LOCAL HISTORIC DISTRICT: Dilworth

PROPERTY ADDRESS: 2116 Charlotte Drive

SUMMARY OF REQUEST: Detached Garage

Charlotte Historic District Commission Case 2017-407
HISTORIC DISTRICT: DILWORTH
ACCESSORY STRUCTURE

5 Front Elevation
A-3 | / 4" = |' - 0"

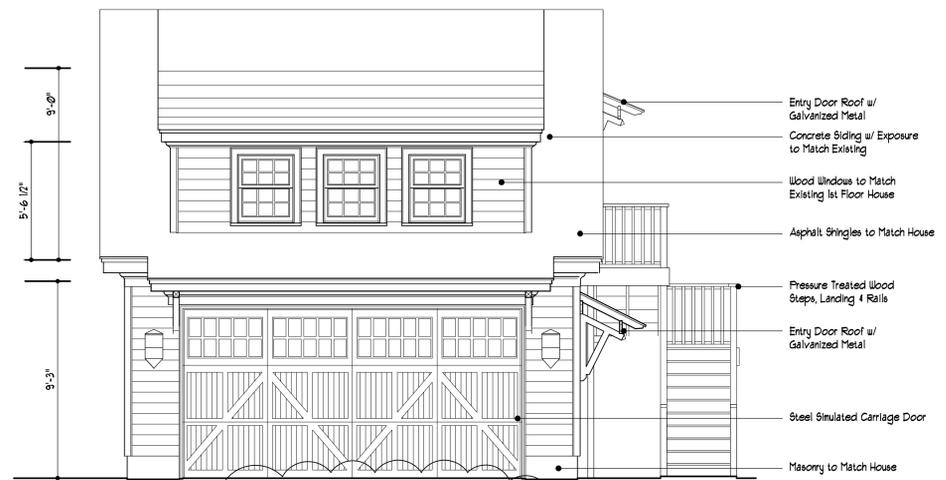
The application was continued for the following: The front elevation of the garage should reference the original details on the front elevation of the house.

1. The front dormer roof on the garage has been revised to reflect the dormer on the house.
2. An updated site section has been included.
